From: Karl Roberts <Karl.Roberts@arun.gov.uk>
Sent: 19 December 2019 16:47
To: Planning.Responses <Planning.Responses@arun.gov.uk>
Subject: FW: A/100/19/PL - Arundel Acre - response to WSCC

From: Ian Hayward <[REDACTED]>
Sent: 19 December 2019 08:35
To: Joney Ramirez <[REDACTED]>
Cc: Karl Roberts <[REDACTED]>
Subject: RE: A/100/19/PL - Arundel Acre - response to WSCC

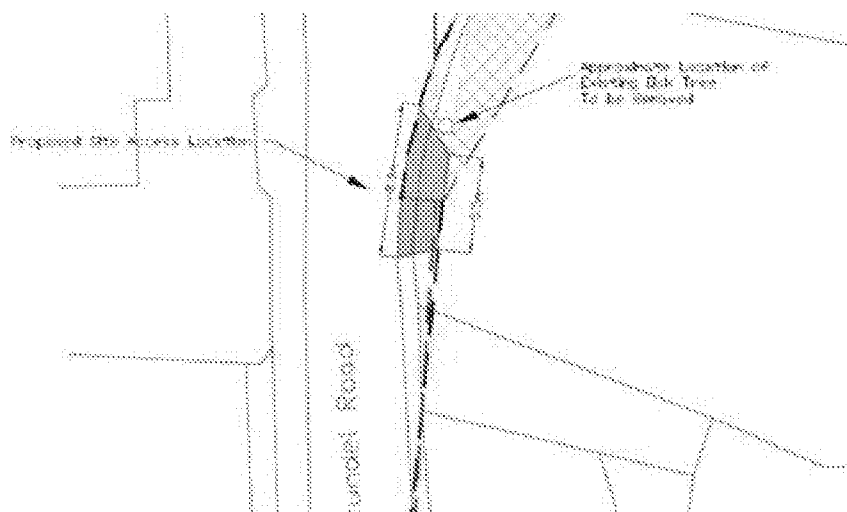
- iv) Noted, the Local Planning Authority advised to ensure this is the case. Scaling of the currently submitted red edge Location Plan makes this difficult to determine. For clarity highlighted below is the area that the Local Highways Authority had previously queried as potentially being 3rd party land but required to formulate the visibility splays.

iv. **It is acknowledged an improvement over the existing situation; however it appears the southern splay will require the use of 3rd party land** – We welcome the LHA's acknowledgement that the proposed relocation of the access will represent an improvement compared to existing and, in order to provide clarification, the proposed splays **will not** require the use of 3rd party land.
